Re: WSSC Staff Comments on M-NCP&PC Request to Evaluate Alternatives to
Proposed Black Hills Park Trunk Sewer

RE: WSSC Staff Response to M-NCP&PC on Alternatives to Proposed
Black Hills Park Trunk Sewer

RE: WSSC Response Number 3 -- Alignment and Alternatives for Proposed
Black Hills Park Trunk Sewer

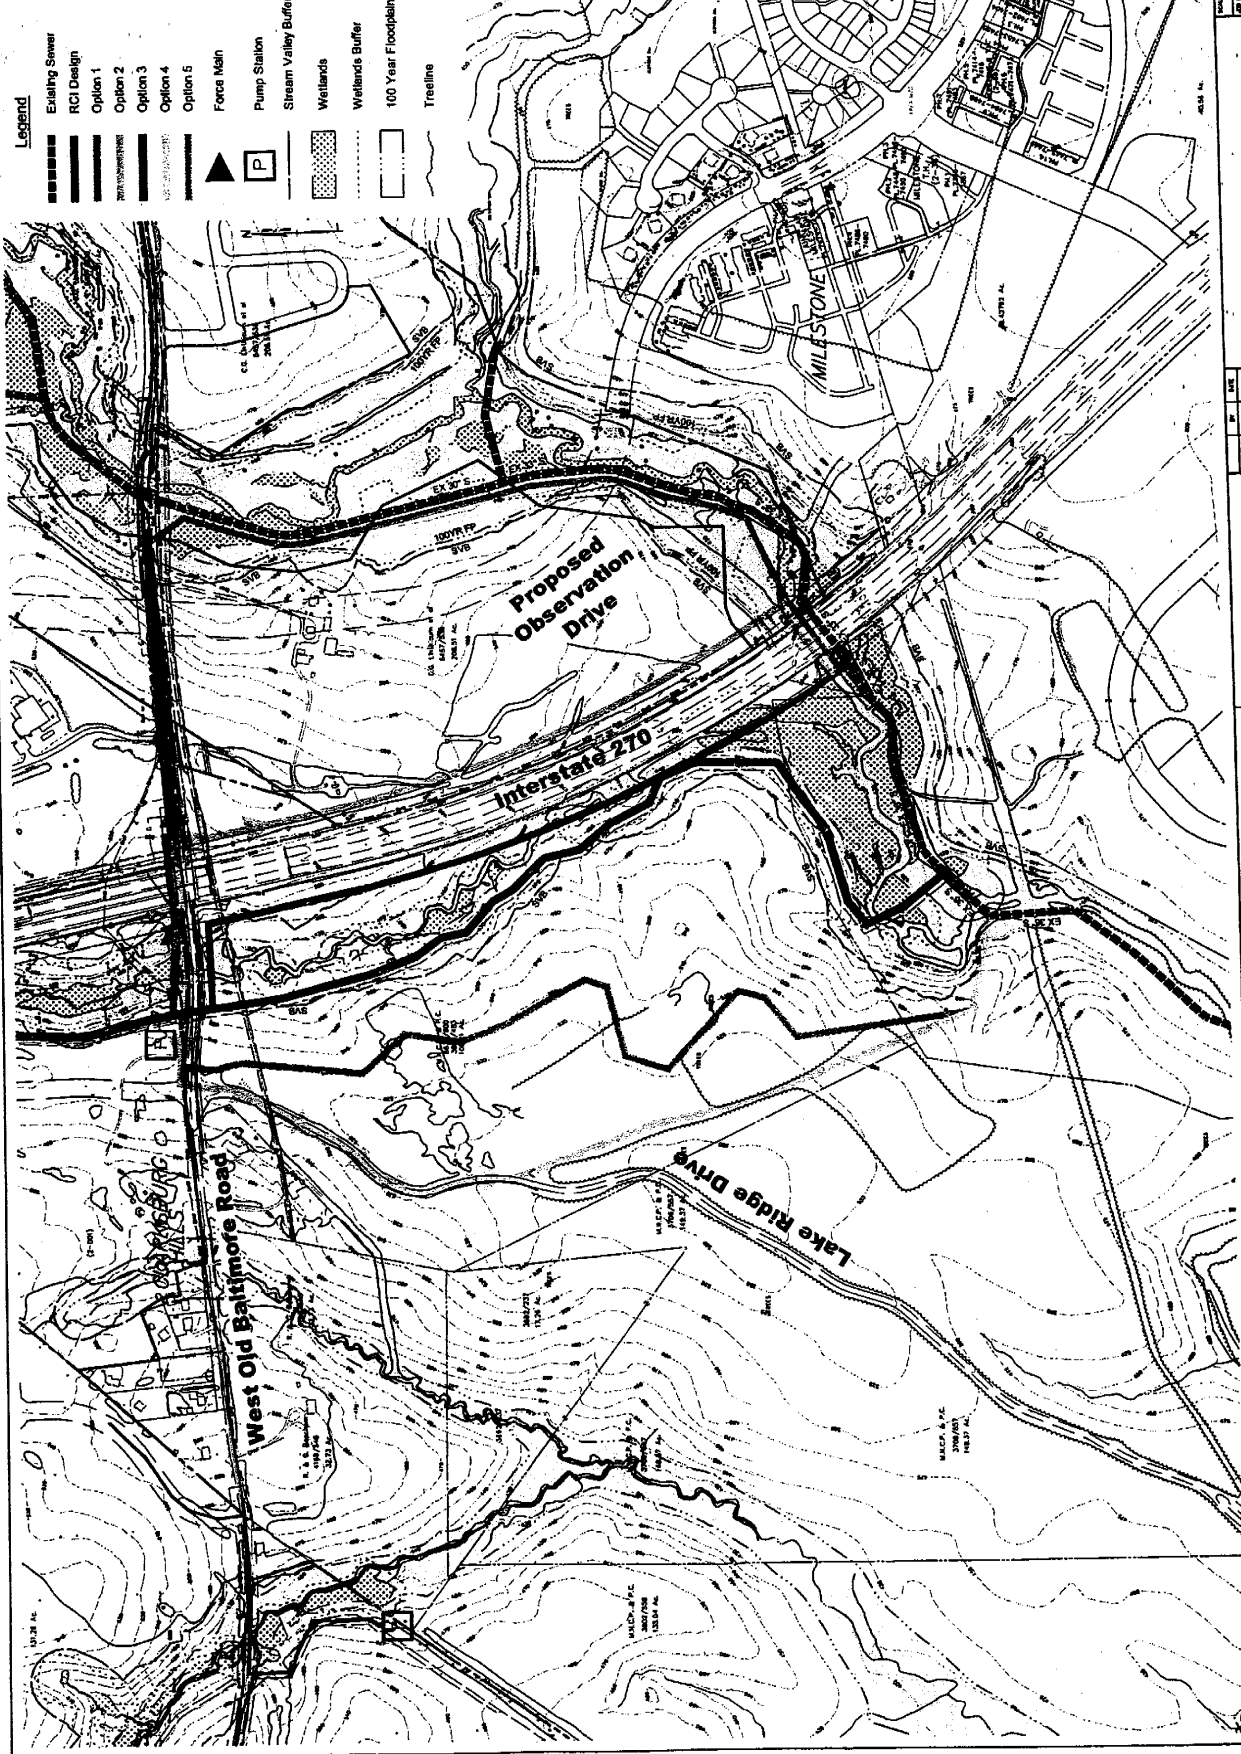
It is unclear why the forest clearing needs to be as large along Lake Ridge Drive as indicated for Alternative 4. It is not clear why a forest clearing, larger than the clearing shown on the CIP forest conservation plan is necessary.

Rodgers staff assumed that the forest clearing of 50 feet along Lake Ridge Drive as a preliminary estimate. As no construction within Lake Ridge Drive is assumed, clearing would be required on one side of Lake Ridge Drive. If the line were placed within Lake Ridge Drive, this would incur additional costs not currently included in the cost estimates. The clearing for the CIP line has been determined in coordination with a detailed survey of the area, along with several walkovers and meetings at the site. The 50-foot clearing represents a "worst case" scenario. If the clearing were minimized, it would still have little impact on the high overall cost of Alternative 4, as a pump station would be required for this alignment.
